STAFF REPORT

RZ/FDP 2014-BR-007

FOREST RIDGE

CONCEPTUAL DEVELOPMENT PLAN FINAL DEVELOPMENT PLAN (CDP/FDP)

Drawing Title
LANDSCAPE PLAN

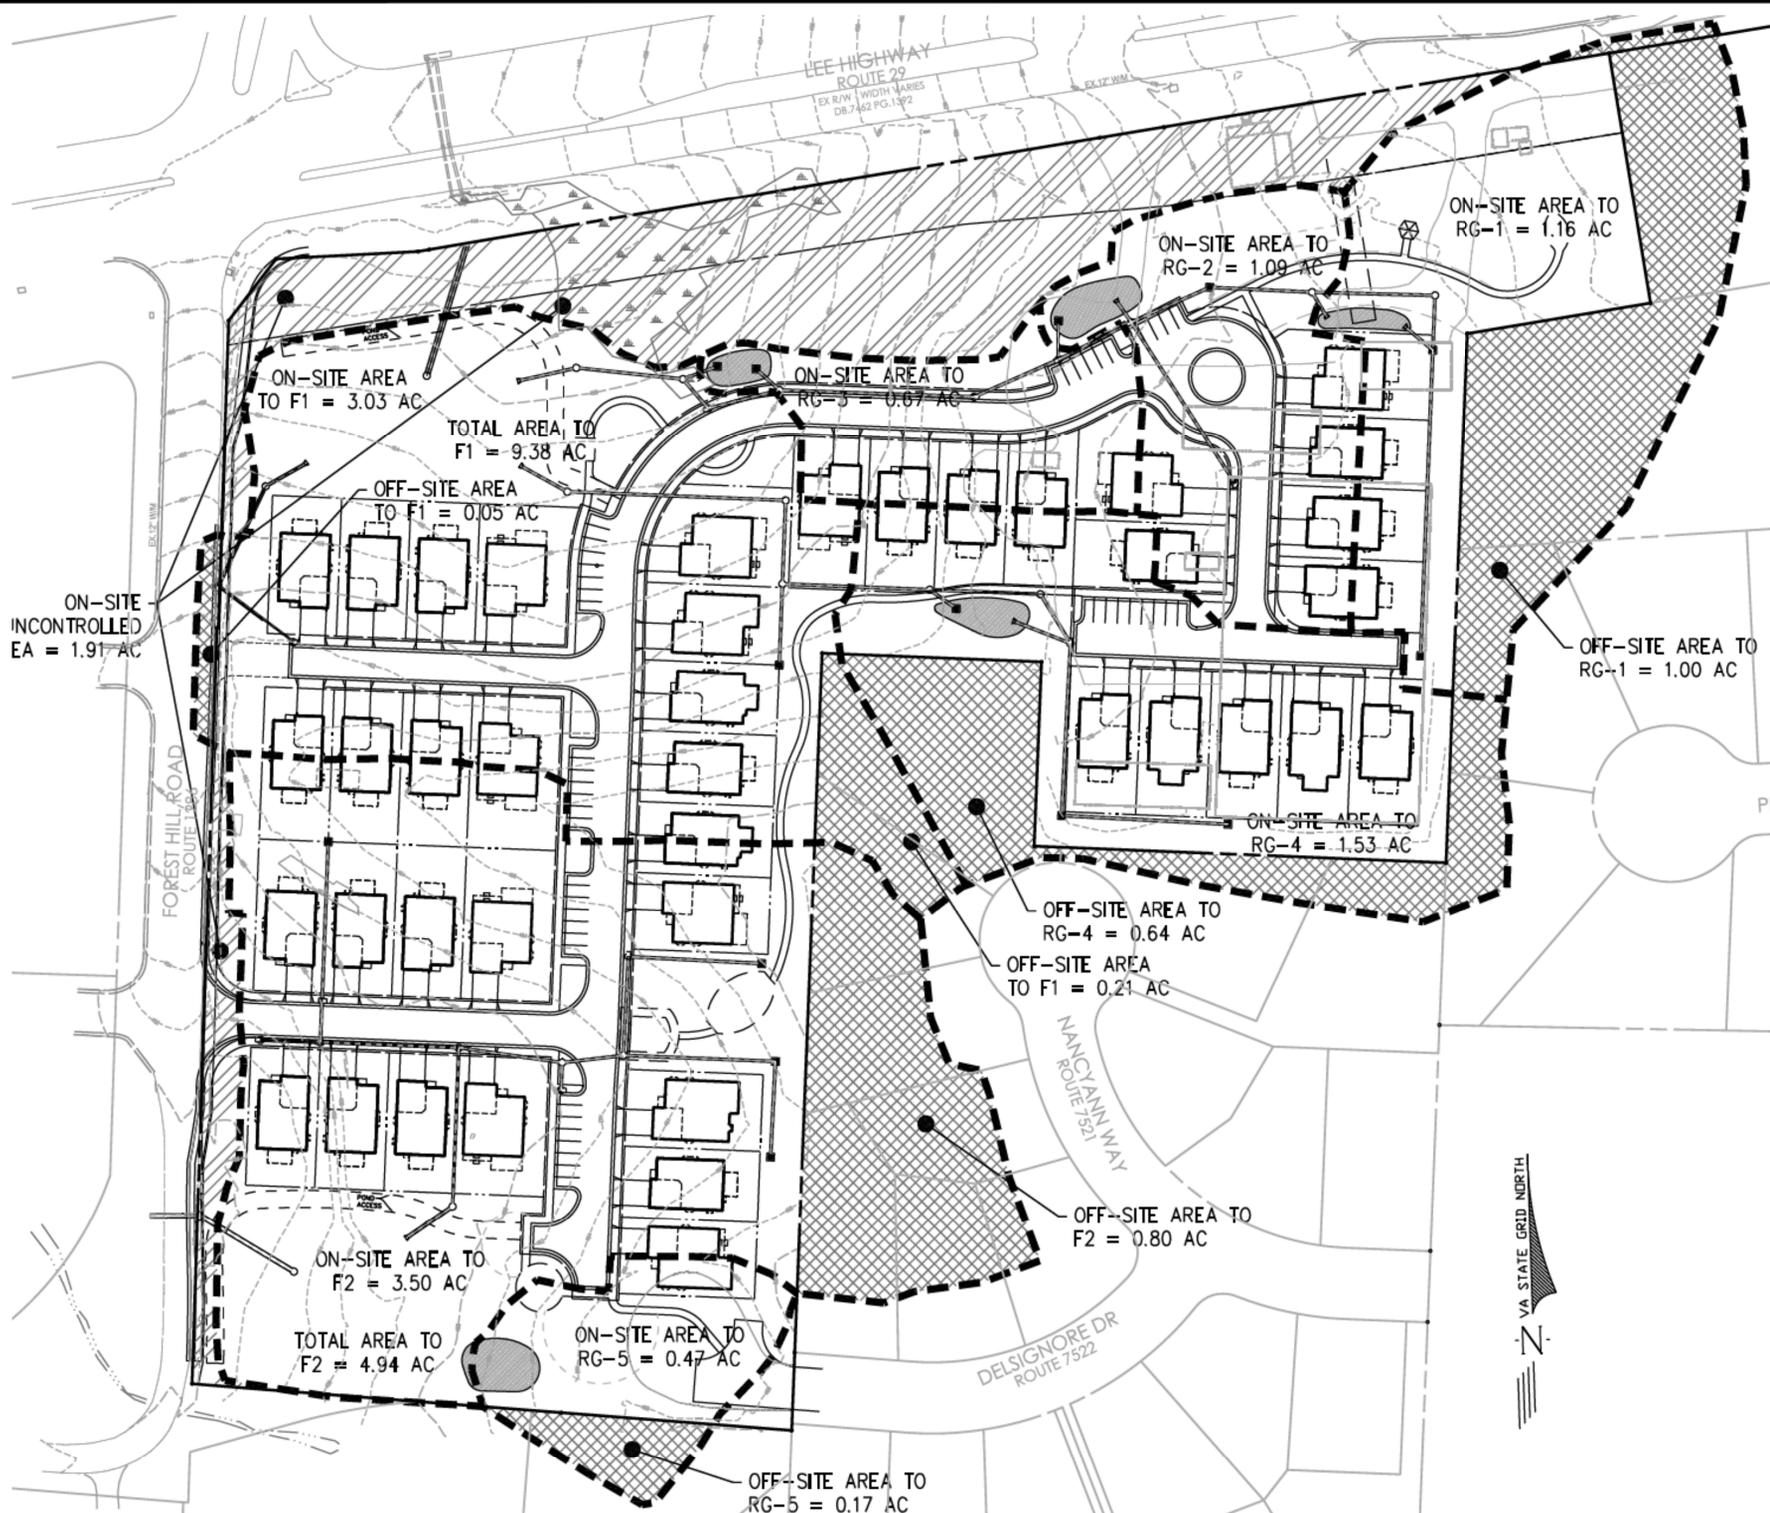
- 1. Comment:** It appears that a request to deviate from the tree preservation target has been submitted on sheet 2. At this time a deviation is not supported by the Urban Forest Management Division as an alternative design may provide additional tree preservation opportunities.

Figure 11: Proposed drainage areas.

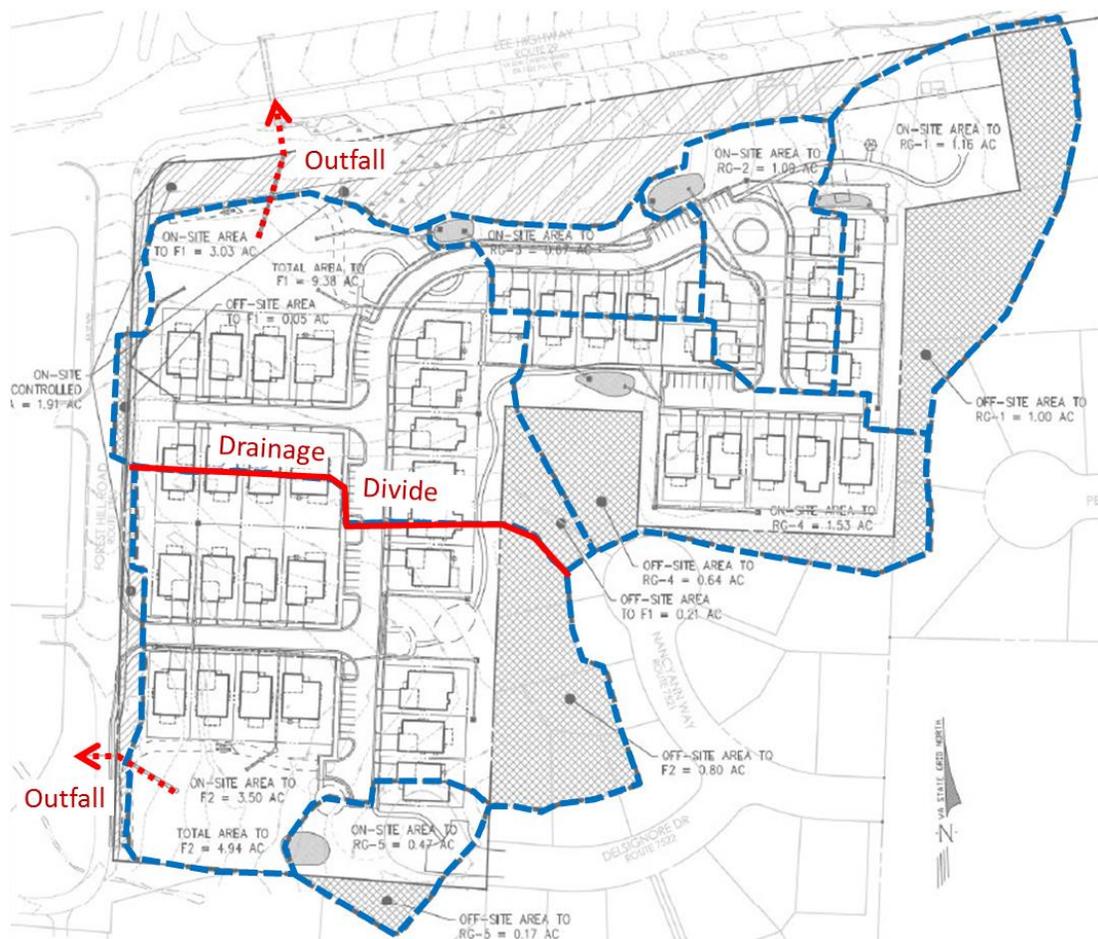
According to the Preliminary Adequate Outfall Analysis on Sheet 8 of the CDP/FDP, both outfall conditions would be adequate to convey a post-development 10-year storm event without accounting for the proposed detention

facilities. The addition of the detention facilities would represent further improvements. At the time of site plan review, outfall conditions would be evaluated by DPWES and the proposed detention facilities required to be sized to ensure no additional peak runoff to either outfall, up to a 10-year storm event, and to mitigate any adverse effects of potential storm events beyond that amount.

Figure 12: Projected future noise contours (based on one additional lane).

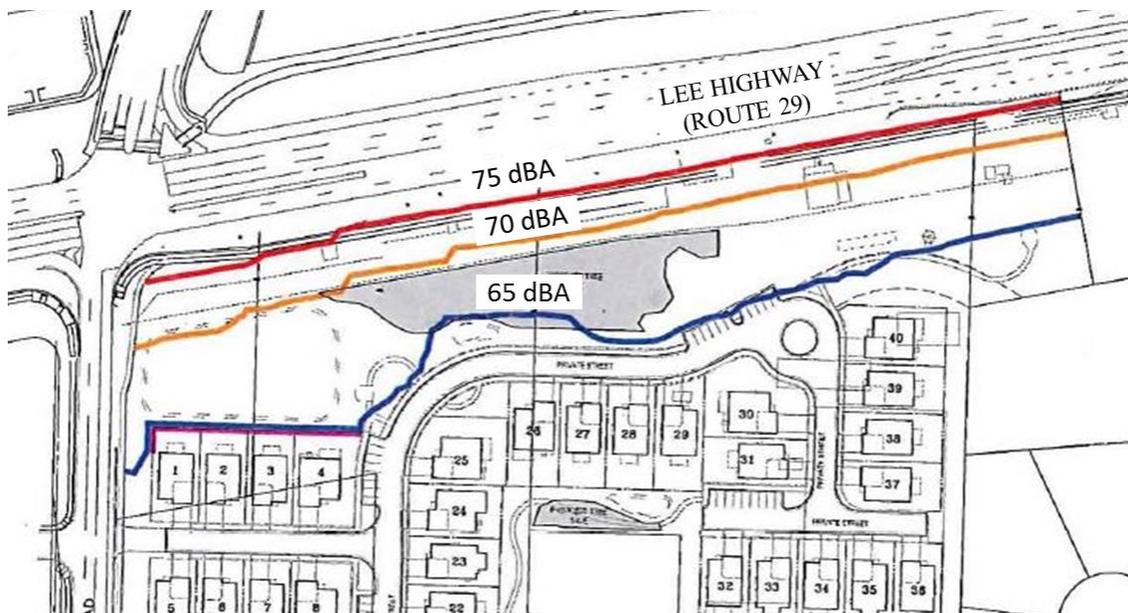
ISSUE – The provided acoustical study projected future noise levels based on one additional east bound lane on Route 29 that is nearing construction, but did not consider long-range improvement plans that include a grade-separated intersection at Shirley Gate Road, and additional one-way collector-distributor lanes on both sides of the roadway. Staff understands that the effect of such future improvements is difficult to predict, since the current long-range Route 29 plans remain conceptual and no detailed design information is available, but remains concerned that such improvements might result in an additional lane even closer to the property boundary, and might result in additional noise impacts that were not considered in the study.

While the applicant has designed the site in a manner which minimizes the number of units that would be exposed to noise impacts, staff believes that it would be optimal for the applicant to provide a more detailed commitment in support of Policy Plan guidance regarding noise mitigation for new residential use. The applicant is strongly encouraged to include the appropriate building materials specifications capable of mitigating noise to address 70 – 75 dBA for the identified units, based on the lack of information available regarding possible long-range road improvements. Finally, additional details should be included on the CDP/FDP, including section or elevation views of the proposed acoustical fencing (sound walls) that offer further specification and design features of proposed materials; landscape treatments; possible terracing and other design elements. Staff has proposed a development condition to address these concerns.

Figure 14: Existing/proposed lane configurations at Forest Hill Dr./Route 29.

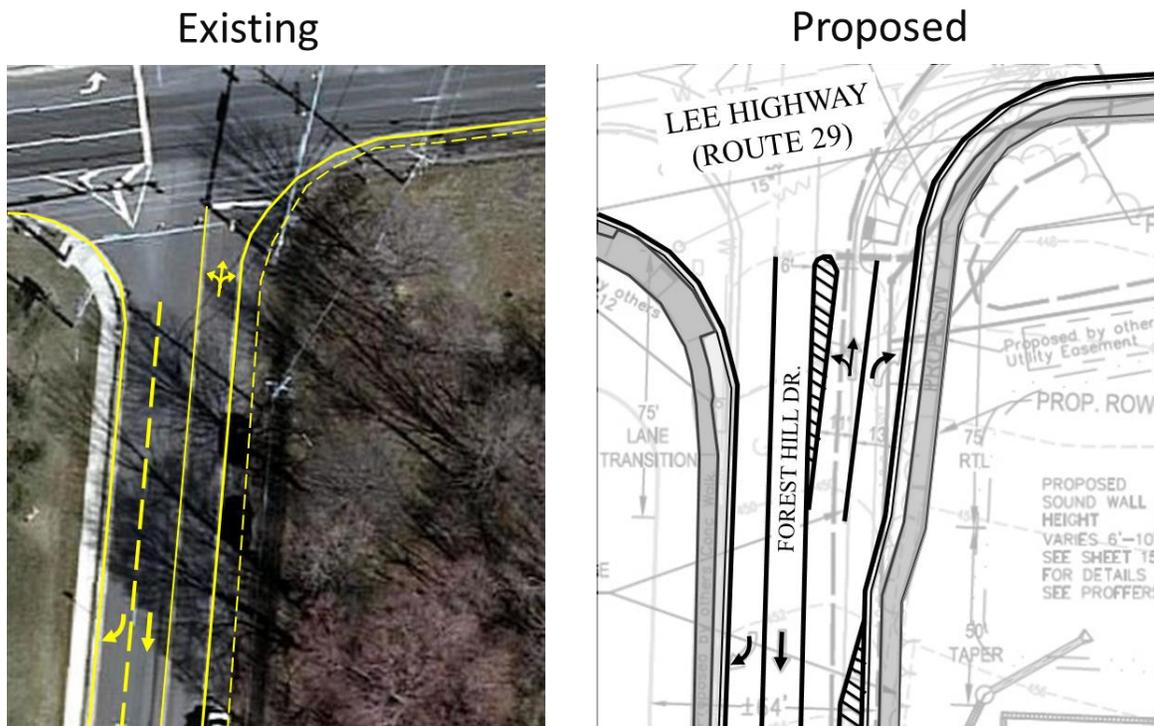
ISSUE - The turn-lane improvement has been coordinated with the pending Route 29 widening project, to ensure that the proposed improvement would integrate with the upcoming Route 29 project. The proposed turn-lane did result in the need for a last-minute design change to the utility relocation portion of the Route 29 project, which was already nearing implementation, in order to relocate the signal mast pole at the intersection to accommodate the current proposal.
